**UNITED STATES
NUCLEAR REGULATORY COMMISSION**
WASHINGTON, D.C. 20555-0001

SUBJECT: SUMMARY OF THE PUBLIC MEETING TO DISCUSS THE NUCLEAR
ENERGY INSTITUTE'S PRE-SUBMITTAL OF NEI 20-07, DRAFT C,
HELD ON MAY 18, 2021

ENCLOSURE 2: NRC STAFF COMMENT ON NEI-20-07, DRAFT C

Figure 1

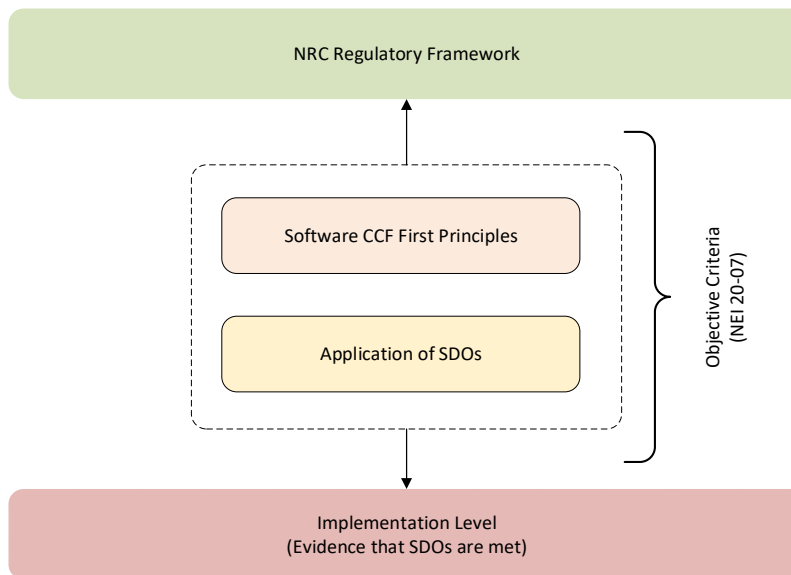
Commented [A13]: It is not clear what this paragraph is "in contrast" to. What is it in contrast to? What is being contrasted to what?

Figure 2

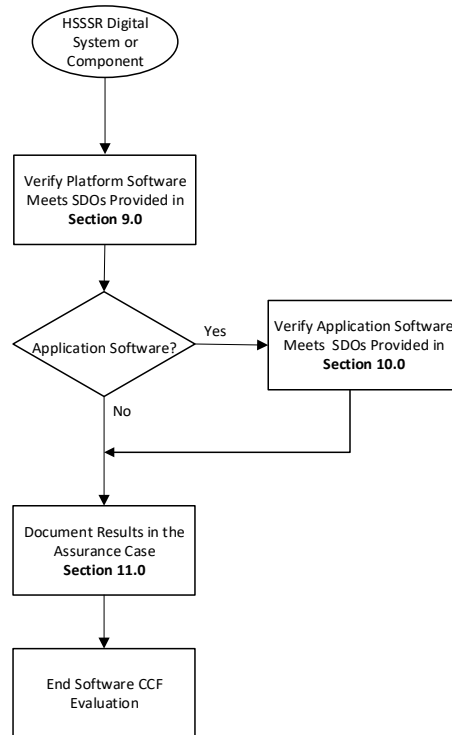
Commented [A18]: This process appears to have no option for inability to verify SDOs are met, yet there is an option for some not being met with justification (i.e. taking exceptions).

That aspect of the process should be clarified (consider accompanying the figure with a description).

Figure B-1 - Simplified Assurance Case Structure

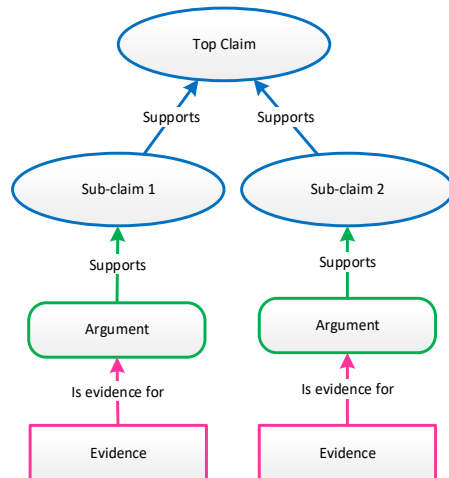
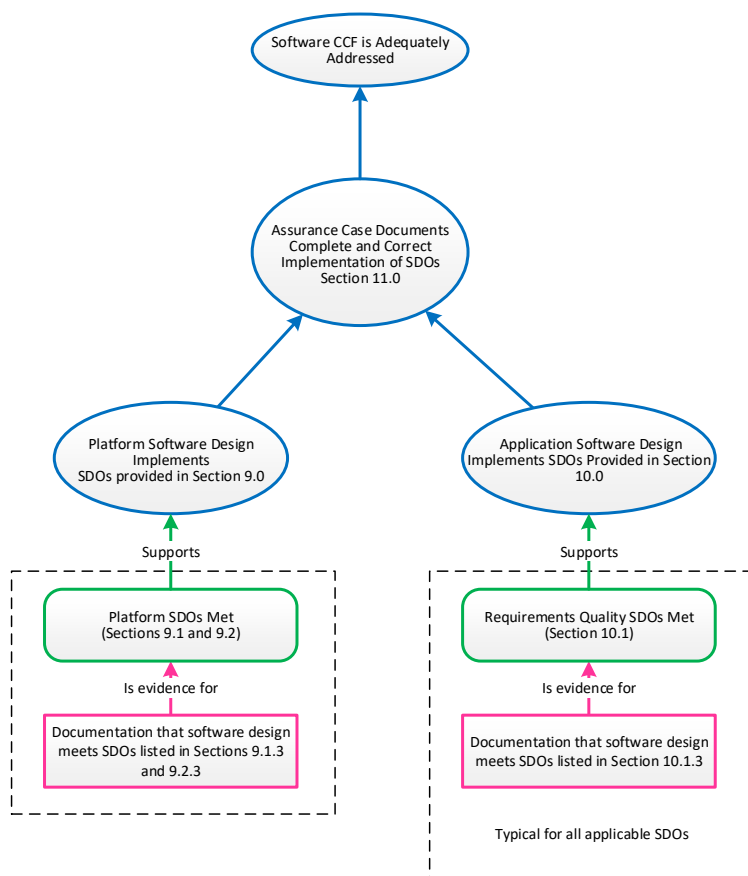
Commented [A51]: Believe this should be 15026-2

Staff believes it made this comment in a previous comment phase. Please ensure that all of our previous comments were read and addressed.
